SURFACE VEHICLE INFORMATION REPORT

J2856

Revised Proposed Draft
2015-01-20

User's Manual for the 50th Percentile Male Hybrid III Dummy

Figure 12 - Neck rubber noddling blocks on nodding joint

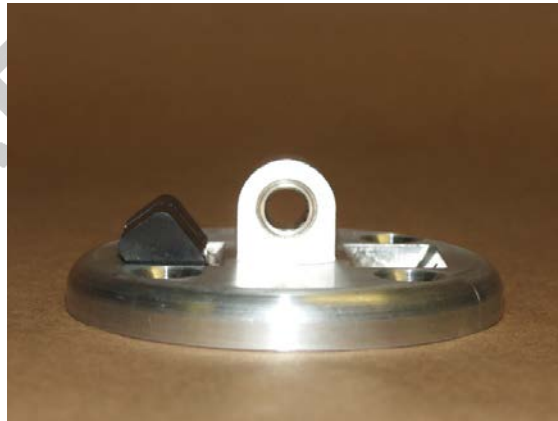
~~Section 3.7 — Figure 12 was replaced to more clearly show the correct orientation of the nodding blocks~~

Figure 27 - Displacement transducer and set screw

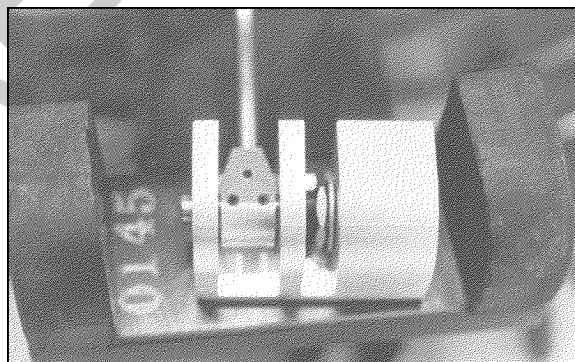
Section 3.9 — changed the disassembly instructions for the sternum from “Detach the bib assembly after loosening the set screw (Figure 27) on the chest displacement slider arm at the displacement pot” to “Detach the bib assembly. Do not loosen the set screw (Figure 27) because this will invalidate the chest pot calibration of SAE Recommended Practice J2517.”

Figure 72 - Hysteresis regions

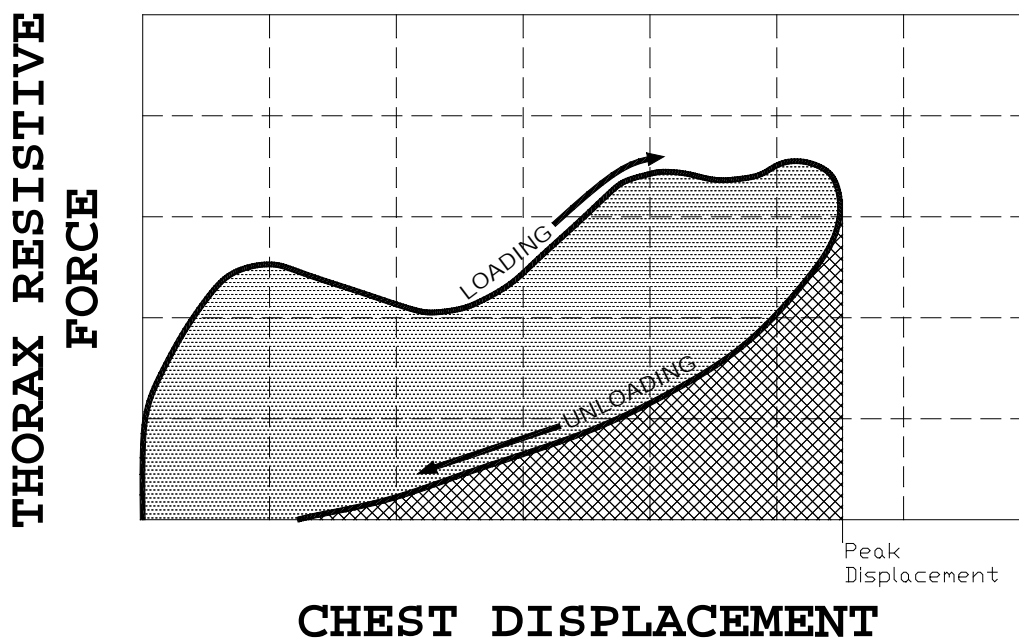
Section 4.5 (E) 3 — added “as shown in Figure 72.” Inserted a new figure and the figure title “FIGURE 72 — HYSTERESIS REGIONS.” Indexed the figure numbers of Figures 72 through 78 from EA-23

Figure 74 - Knee slider test set-up

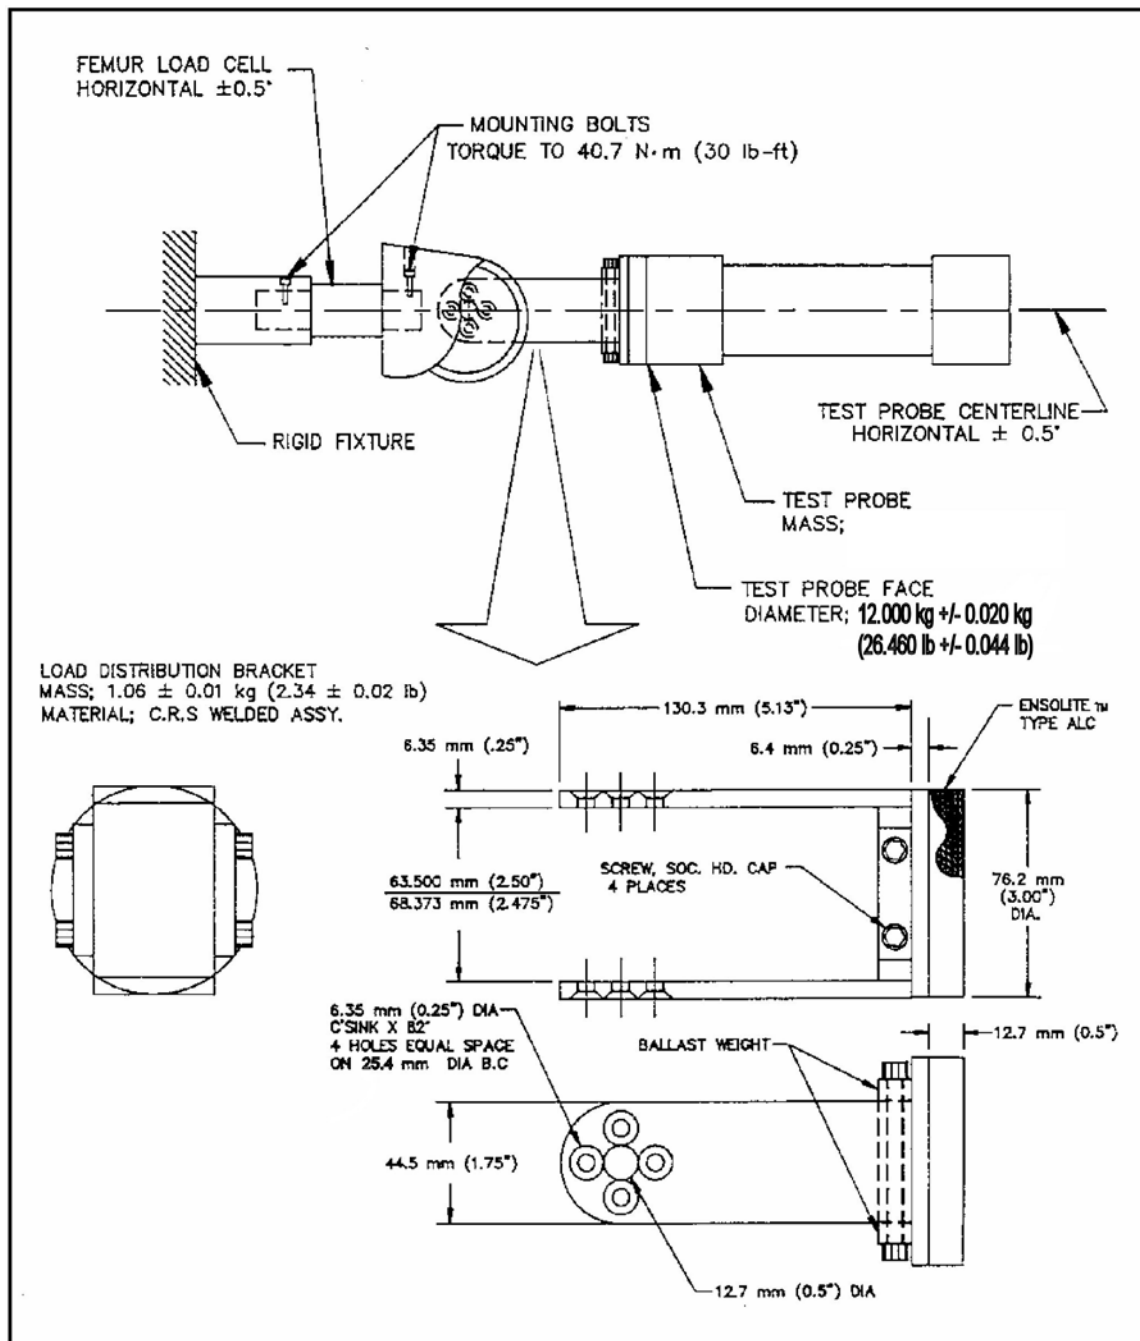
Section 4.7 (C) — replaced Figure 74 with corrected probe mass and hole diameters. The figure was Figure 73 in EA-23.

Figure 75 - Hip joint range of motion calibration set-up

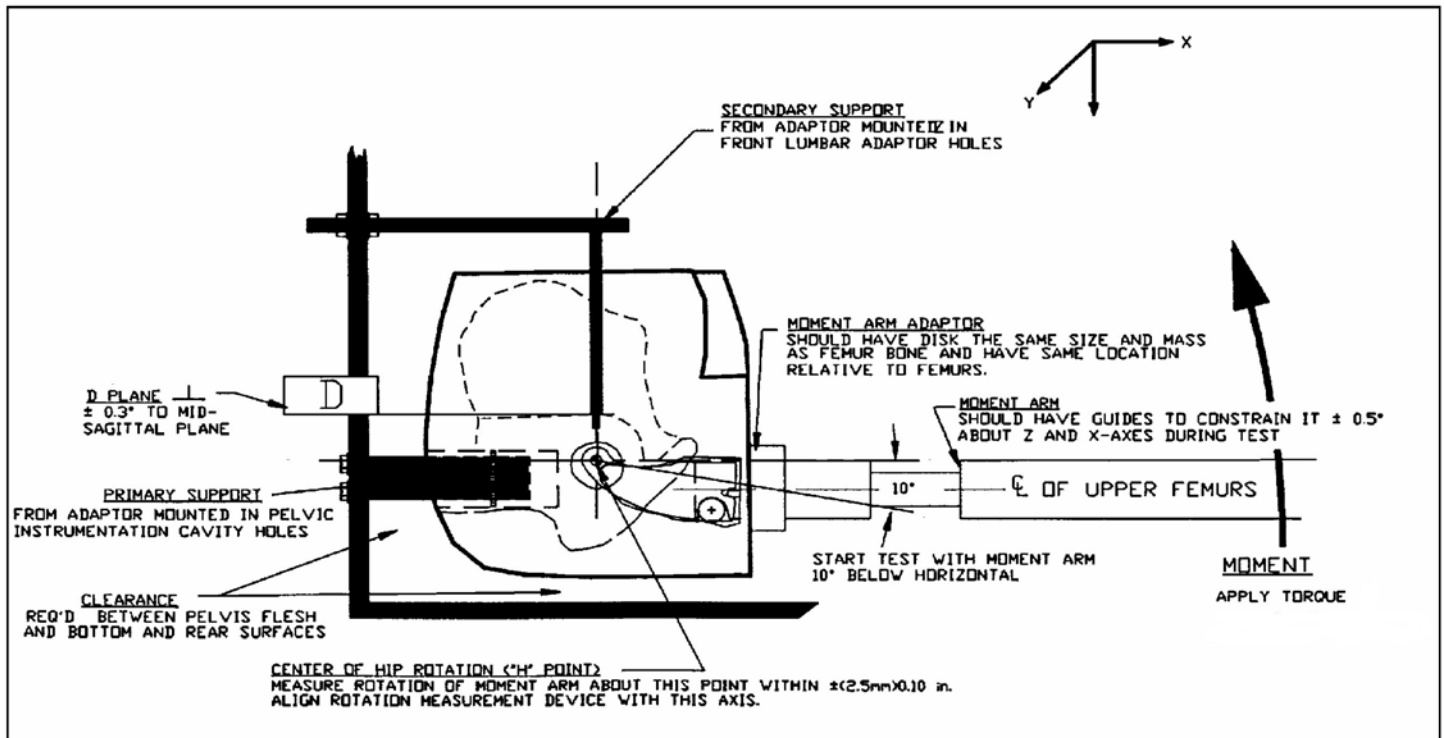
Section 4.8 (C) — replaced Figure 75 to remove incorrect loading rate from EA-23. The figure was Figure 74 in EA-23

Figure 79 - Initial foot position for ankle test

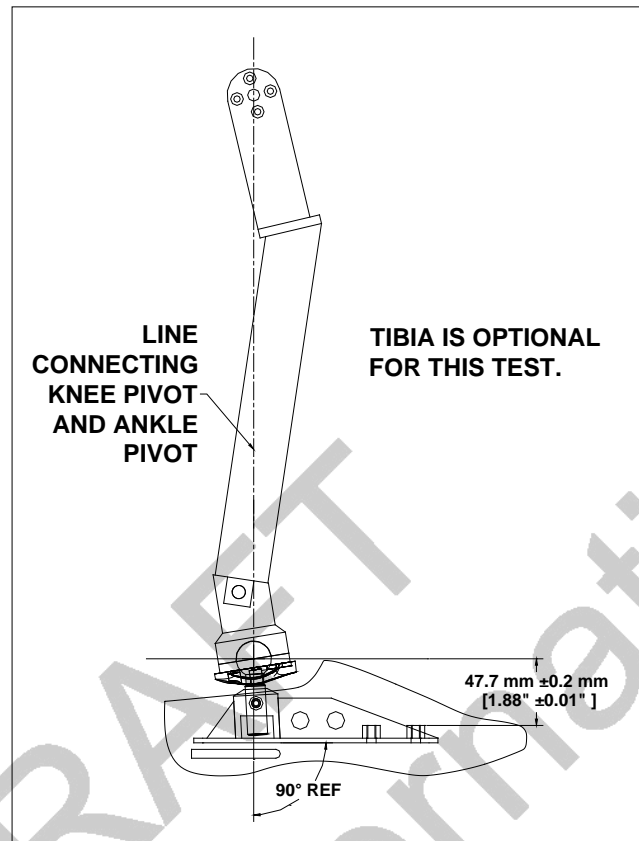
~~Section 5.4 (E) 2 — Was section 5.2 (E) 2 in EA-23. — The notation on the angle referenced in the bottom of Figure 79 was corrected from “50° REF” to “90° REF.” — The figure was Figure 78 in EA-23~~
